Docket No. 50-423  
B13358

Re: 10CFR50.90

Millstone Nuclear Power Station, Unit No. 3  
Proposed Revision to Technical Specifications  
Reactor Trip System Instrumentation

Figure 1 SOLID STATE PROTECTION SYSTEM

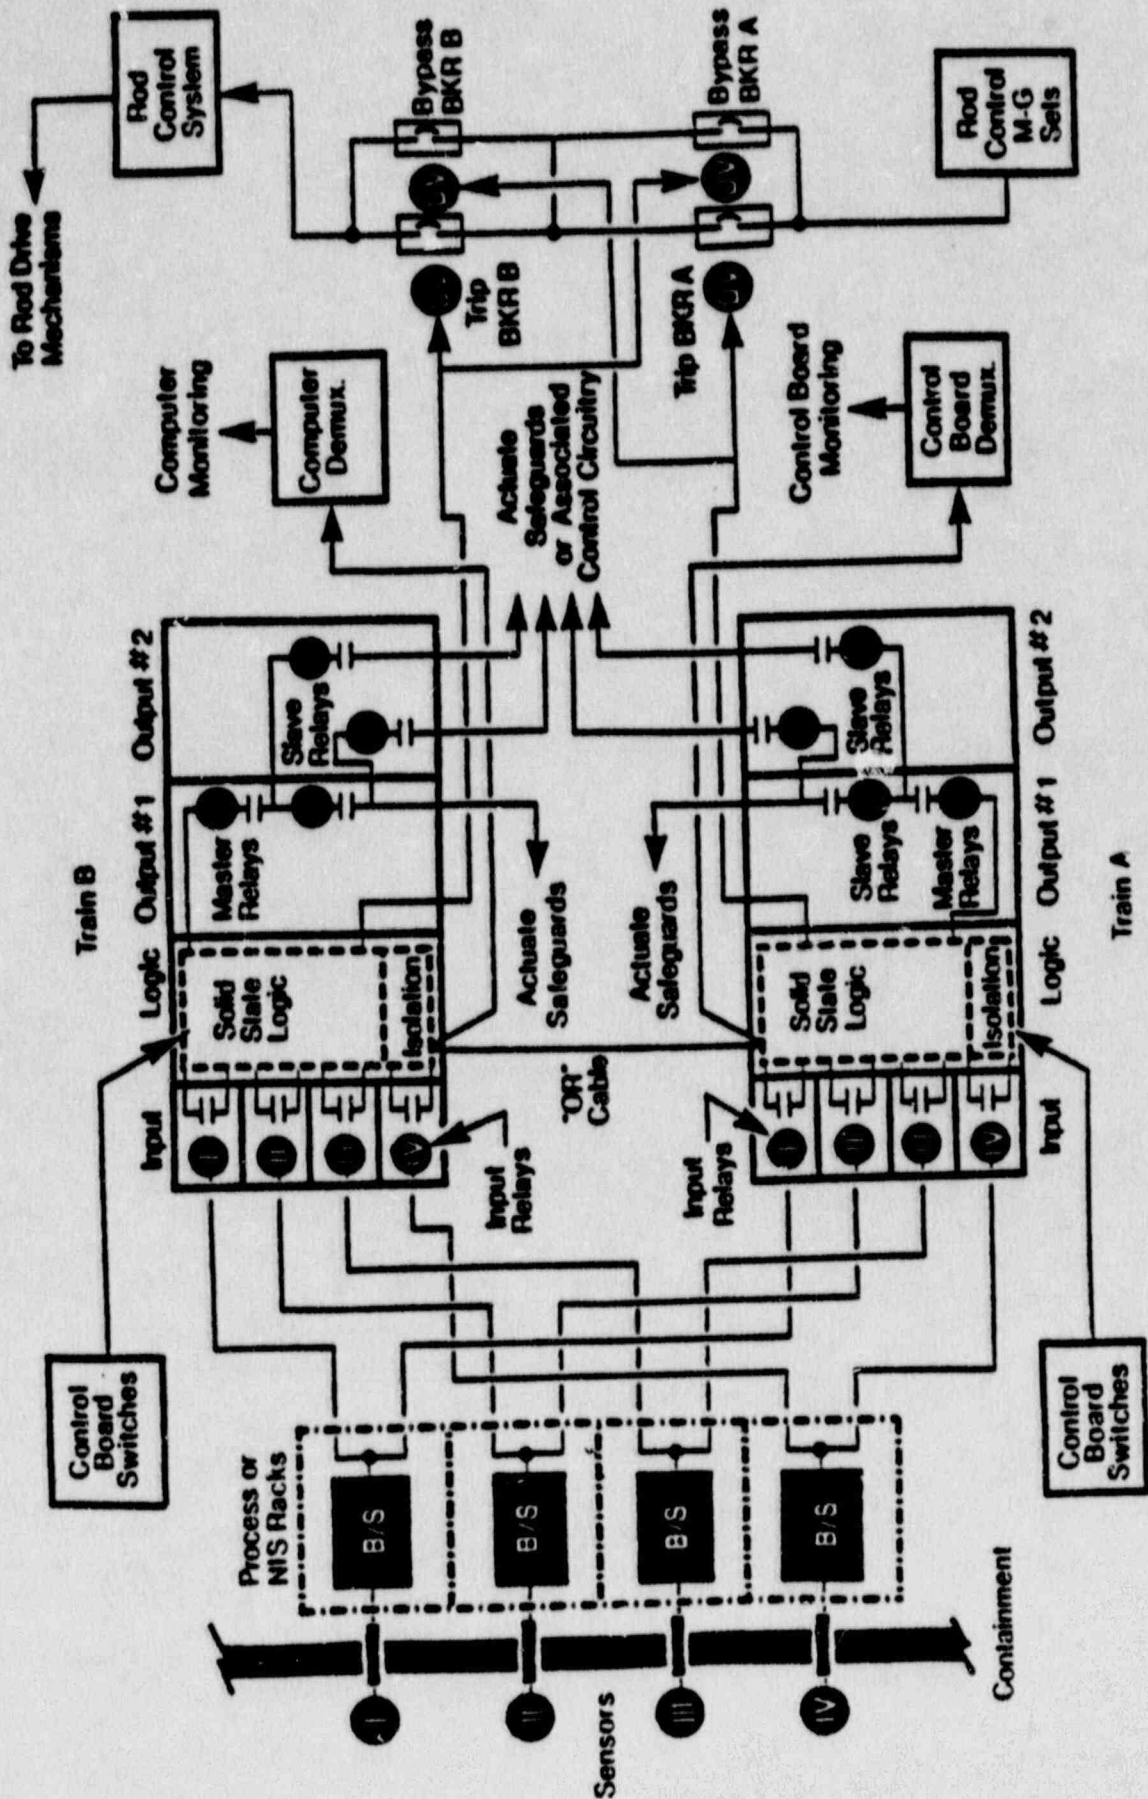
Two independent but redundant protection trains, A and B, receive identical information on plant conditions. Either train can trip the reactor or actuate ESF systems to adequately protect the plant. Instrument channels and protection trains are physically, as well as electrically, separated to achieve independence. This separation starts at the detectors, continues through the cable trays and instrument racks, to the solid state protection cabinets, and to the ESF systems.

With this type of testing frequency, the input relays (both train) of SSPS are not tested as a channel. Therefore, no complete overlap of testing between trains and channels exist. The proposed change is to include the input relays (both trains) of SSPS as a channel. Therefore, when the plant performs a test on Channel 1, the input relays on both trains will be tested along with the channel to determine operability.
